SEWAGE DISPOSAL SYSTEM

MARYLAND STATE DEPARTMENT OF HEALTH

SUBDIVISION Brachburn ROAD Brachburn LOT 24

PROPERTY OWNER John Taggart

INDICATE NORTH - NAME ADJOINING ROADWAY AS BASE LINE.
DANEBOUN Rd.

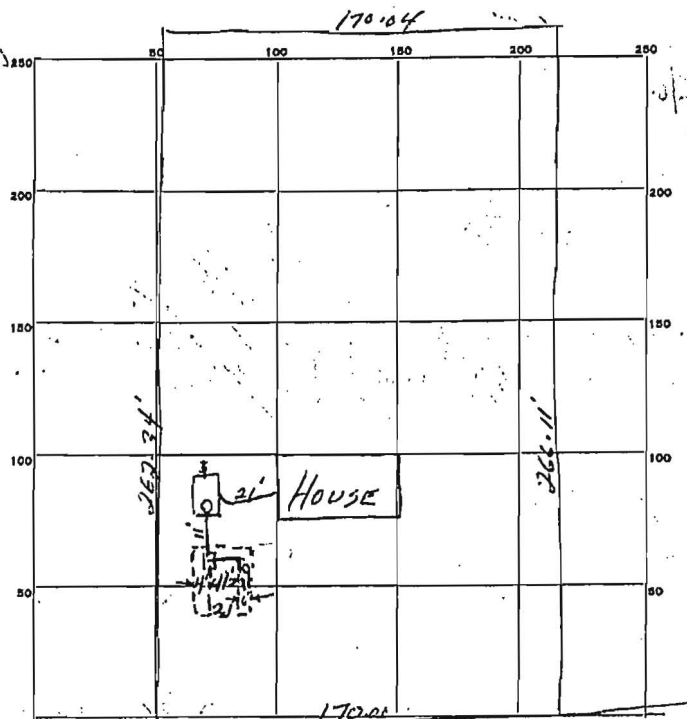
REMARKS 6-25-64 House sewer from tank to house not installed. Need
more pipe in bed - another line between two existing lines. Permit
card set up. J.H. in the middle - pipe does not
penetrate line.

7-1-64 None of the above corrected. Also made tar paper strips
over tiles in bed. J.H. 7-6-64 1st H. message to phone me. J.H.

7-8-64 Above complied with J.H.
